From: [Alex Lohrisch](#)
To: [Easements&Development](#)
Cc: [Guy Smith](#); [Kym Dracopoulos](#); [Michael Platt](#); [Alasdair Cameron](#)
Subject: RE: 2020-471 Oakdale West Estate Modification 6 (SSD-7348 MOD 6)
Date: Wednesday, 10 February 2021 4:55:48 PM
Attachments: [image570313.png](#)
[image803095.png](#)
[image696617.png](#)
[image403605.png](#)
[image946520.png](#)
[image067383.png](#)
[image084966.png](#)
[19.01.21 Acceptable Letter.pdf](#)
[SKC395 - TRANSGRID ACCESS PLANIP11.pdf](#)

Location: Oakdale West Estate Modification 6 (SSD-7348 MOD 6)

Thank you for requesting TransGrid's permission to carry out the Modification application (SSD-7348 MOD 6) described in 15-272-C4167[P1], 15-272-C4168[P1], at Oakdale West Industrial Estate within TransGrid easement Transmission Line 14 Sydney North 330kV – Kemps Creek 500kV + Easement earmarked for future Transmission Line (**TransGrid ID: 2020 – 471**)).

Title **TRANSGRID EASEMENT MAINTENANCE ACCESS PLAN**

Figure 2 - Fencing details

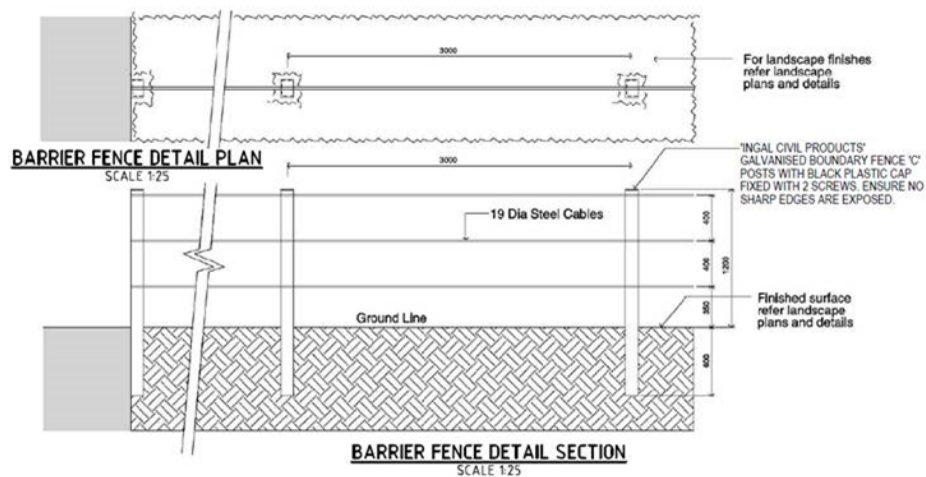
The road works and combined services drawings attached show all subterranean encroachment proposed in the Road 8 construction. This will also help review in the streetlighting in context of road works. CAD File here: <https://atl.sharefile.com/d-se250ce8c1eb94308bacfc45539bf4ba5>
We will be specifying a fence to the road reserve pictured below which will be isolated at easement edges to comply with Transgrid Fencing Guidelines. Would you please confirm this aligns with your expectation?

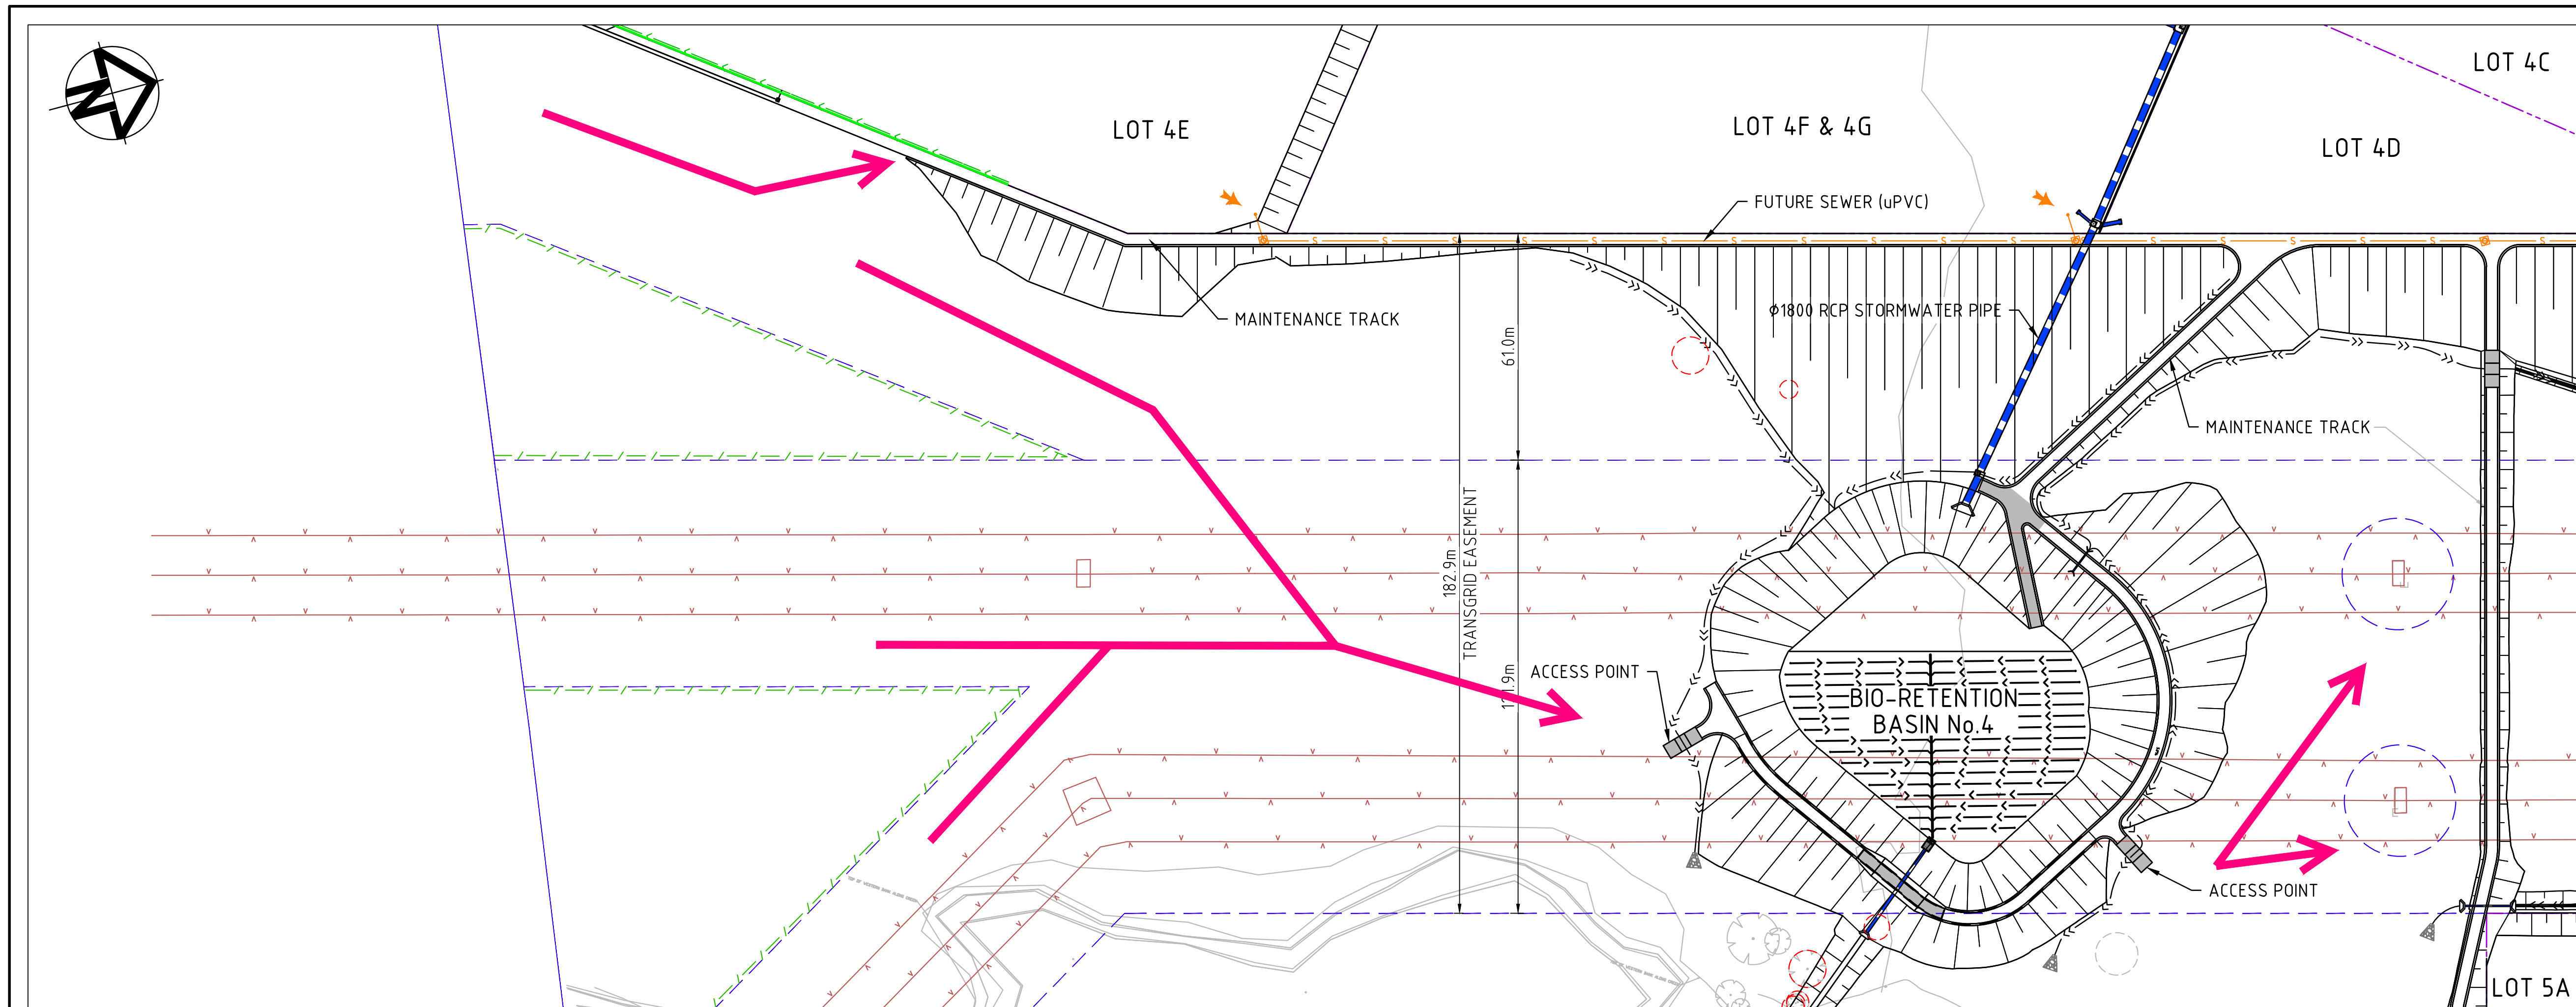
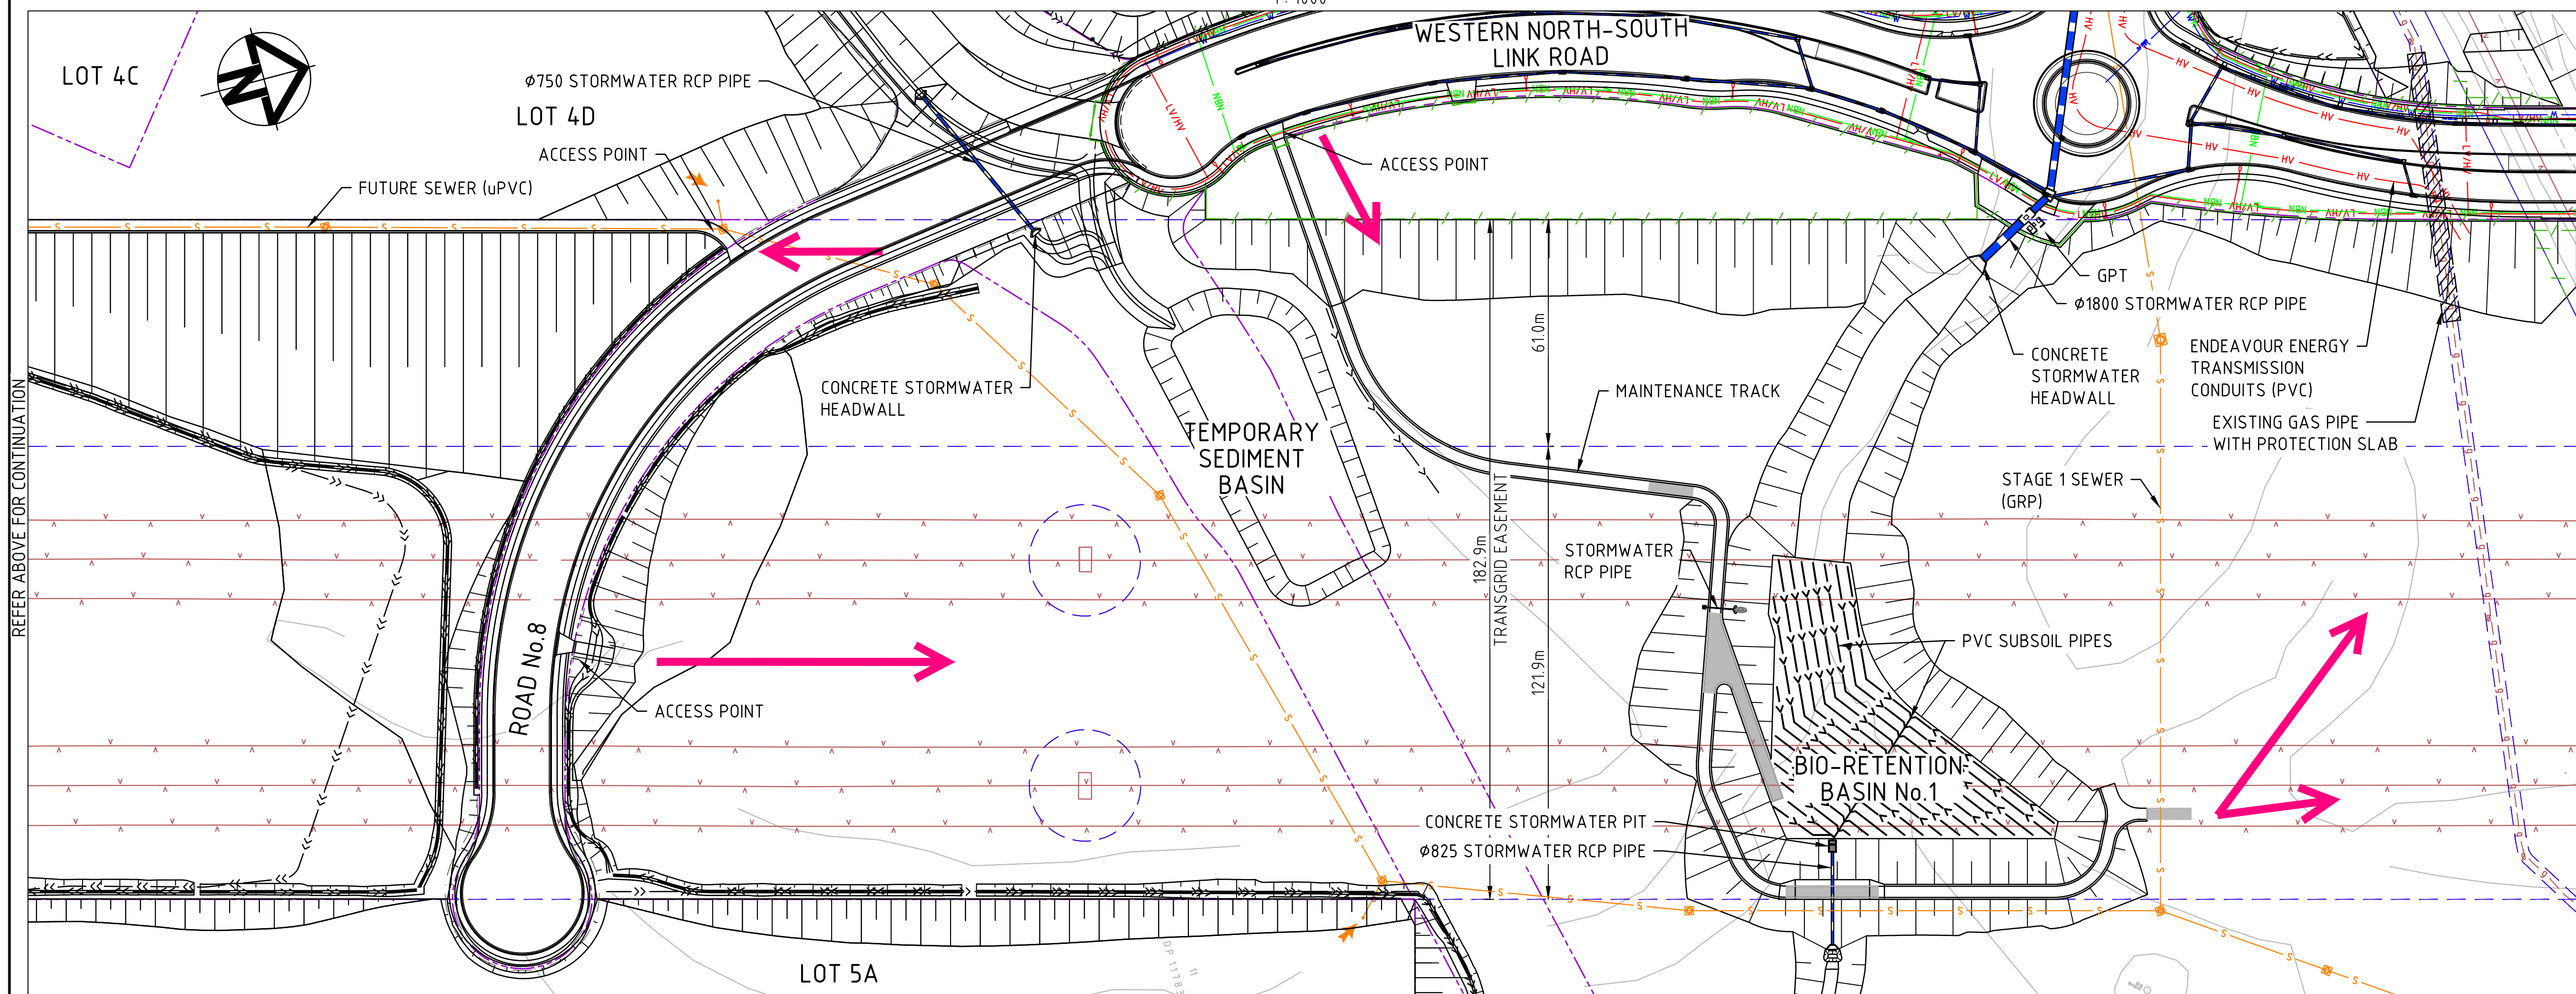
- a. ***Current travel between structures at the location, where possible, is mostly along the easement. It is advised that fences are proposed along the proposed ROAD No.8 reserve and clarification is requested on how the easement and structures at this location are to be accessed***

It is requested that the proponent provides information/clarification on TransGrid's access points and access routes to all the structures at this location – a marked up drawing to indicate these would be most helpful, not only for field staff use but to record in TSS for future visits to these easements by others within TransGrid.

To answer your two queries below, I have created a sketch that should clearly describe access to Transgrid assets within the land. Please note that this is just the main points of access.

1. The Road 8 reserve will be fenced to prevent unauthorised access to the land either side. Transgrid access has been considered and two gated driveways (one on each side) are provided to allow Transgrid to drive from one side to the other.
2. The sketch answers this question. There are numerous tracks supplied to maximise the accessibility throughout the easement.
